Beachlands South

Fast-track Application

Response to s67 Request for Futher Information

22 September 2026

Typical section (illustrative)

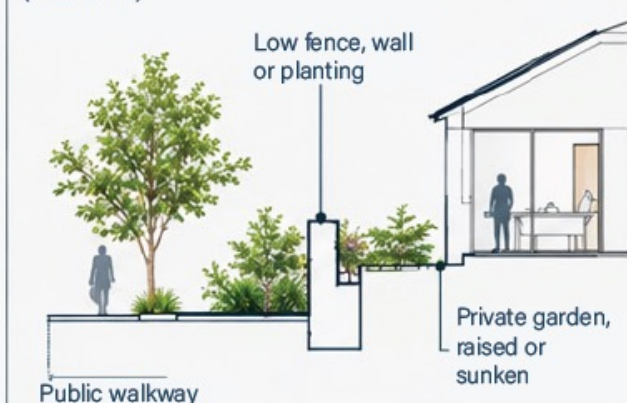
Please clarify whether park-edge road arrangements were considered and tested in locations where residential development directly adjoins parks, EPAN areas or other open spaces. It appears that potential opportunities are present at Marina Point, the Community sub-precinct adjoining EPAN/stormwater open-space areas, and parts of Sub-precinct E adjoining the golf/open-space network.

1. Where park-edge roads were considered but not adopted, please briefly explain the rationale.

2. Where residential development directly adjoins these open spaces, please identify the proposed interface and CPTED strategy, including how passive surveillance, pedestrian access, legibility and the public character of the open-space edge will be achieved.

Where residential lots adjoin public walkways or public open space, design controls will ensure high-quality interfaces and passive surveillance. Blank, high boundary fences will be avoided in favour of more permeable boundary treatments, including low fencing, landscaping, walls, level changes, or similar measures that balance privacy and security with visual connection to public spaces.

Open, permeable planting used with low fences or walls create a softer edge.

High, blank fences and solid walls that prevent overlooking and interaction with adjacent public spaces will not be permitted.
